CHAPTER 4 AGENCY INPUT

**Table 4-1
USACE Comments and CDOT/FHWA Responses**

RE: C-470 Environmental Assessment: Temporary Closure/Section 4(f) Temporary Occupancy of the Willow Creek Trail

Figure 1 – Willow Creek Trail Graphics from the C-470 Revised Environmental Assessment

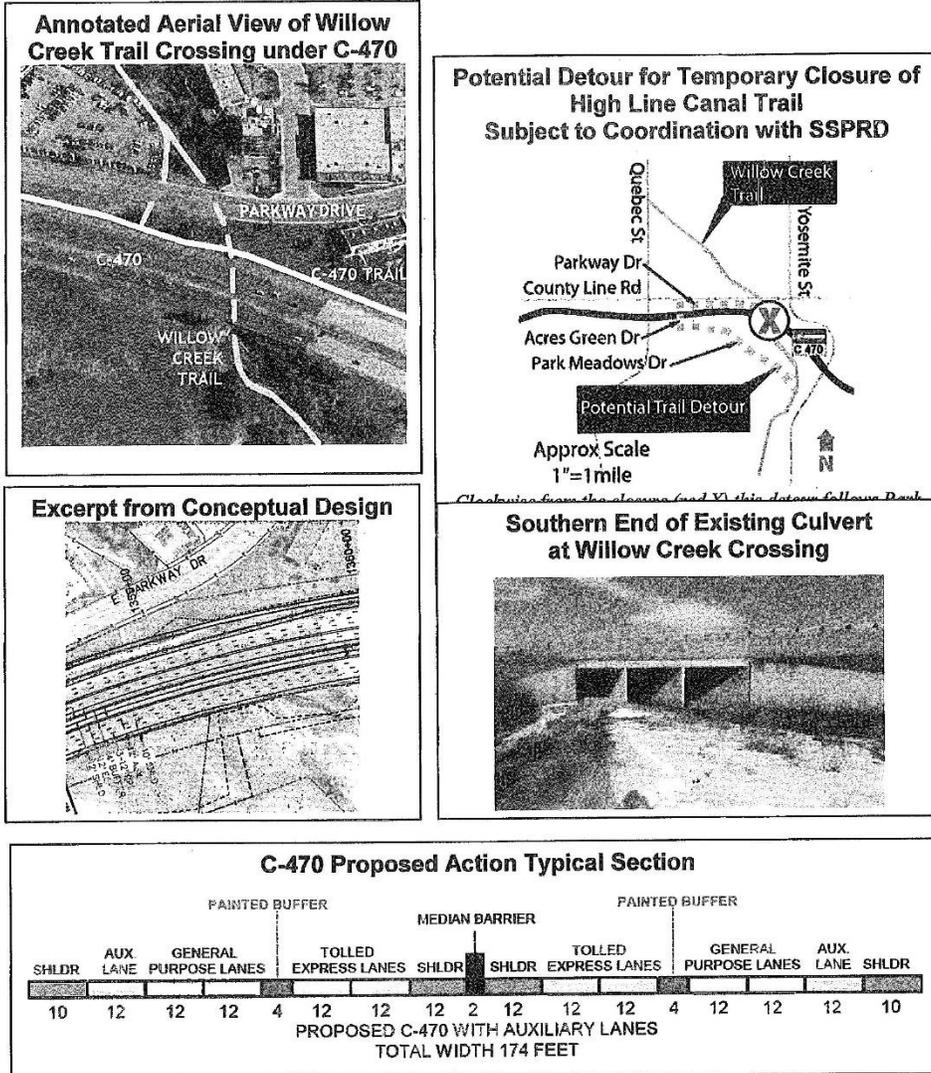
Location and Impact Description: The existing 450-foot long culvert carrying Willow Creek Trail under C-470 will be lengthened by 15 feet southward to accommodate widening of the highway overhead. No trail changes are needed.

Figure 1 – Graphics Depicting the Existing and Planned Mary Carter Greenway Trail Crossing Under C-470

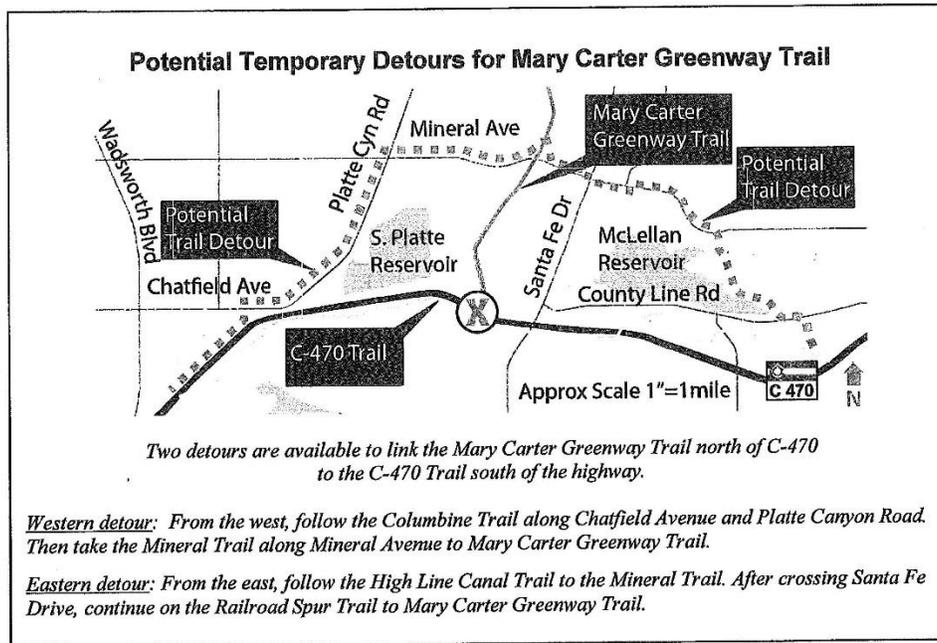
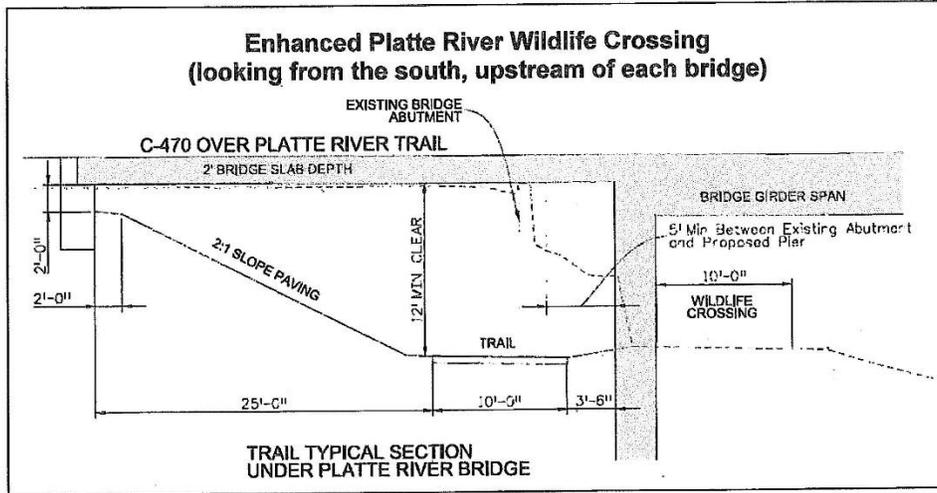
Location and Impact Description: The portion of the Mary Carter Greenway Trail crossing under C-470 will be replaced with an improved trail located typically 18 feet west of the existing one. The Mary Carter Greenway Trail is a paved trail generally oriented north-south as it traverses the CDOT right-of-way for the generally east-west State Highway 470. The trail crosses under C-470 on the western bank of the South Platte River. The two existing parallel C-470 bridges crossing over the river and the trail would be replaced as part of the C-470 Proposed Action. Based on discussions with SSPRD regarding deficiencies of the existing trail at this location, CDOT would reconstruct the trail to provide more vertical clearance and better sight distance, while also creating a dedicated wildlife movement area separated from the trail. For the safety of Mary Carter Greenway Trail users, the trail would be closed temporarily during construction. CDOT has identified potential detours using nearby trails and local streets and/or their sidewalks for SSPRD consideration. Please see the graphics in Attachment 1 for more information.

The figure above shows the existing C-470 bridges crossing over the existing (light/white colored trail). Superimposed on this image, the two new bridges (shaded blue) would be much wider. The new trail alignment (off-white/gray) would have less of a bend, improving horizontal sight distance, and greater vertical clearance, enabling bicyclists and equestrians to cross under the bridges more safely. The trail would be shifted generally 18 feet to the west, away from the river, opening up this space for wildlife movement. Unused portions of the exiting trail will be replaced with a natural surface for wildlife use.

Figure 1 –Graphics Depicting High Line Canal Trail Crossing Site

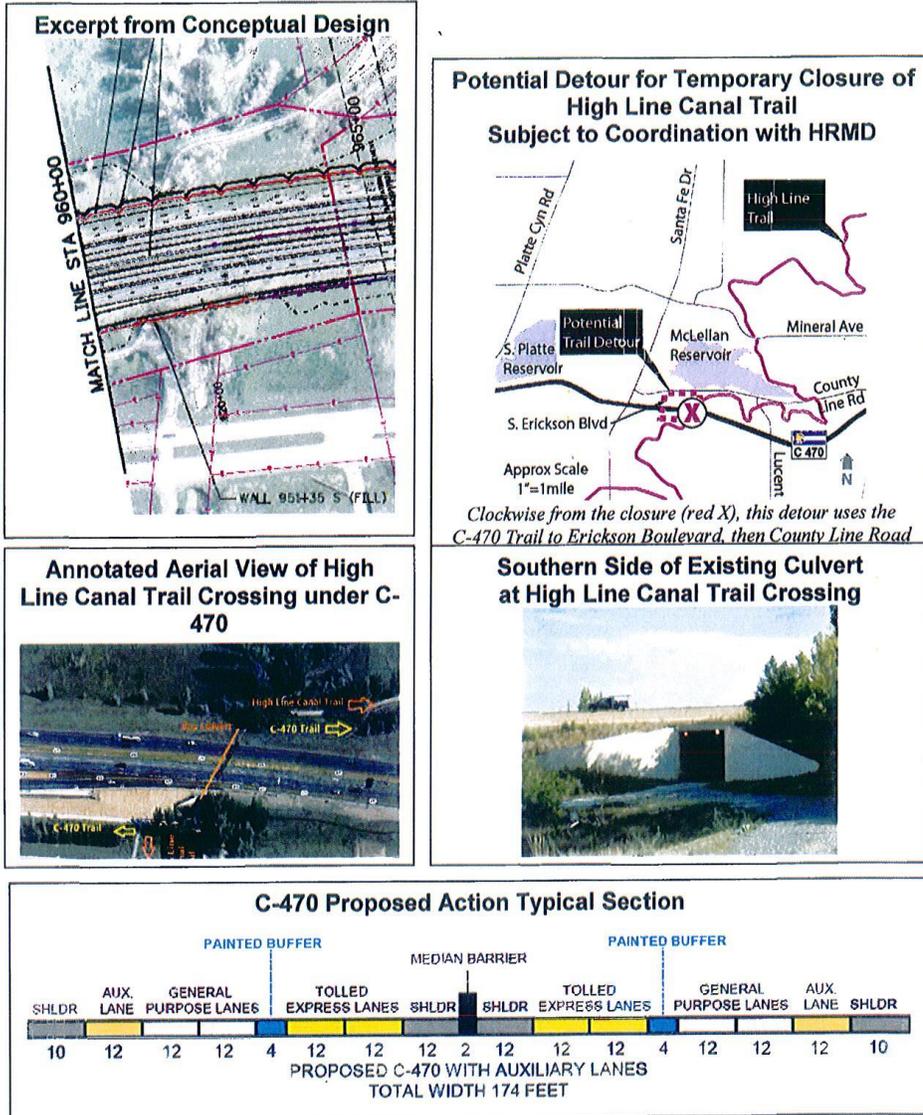
Location and Impact Description: The existing 203.5-foot long culvert carrying the High Line Canal Trail under C-470 will be lengthened by 25 feet southward to accommodate widening of the highway overhead. No trail changes are needed.
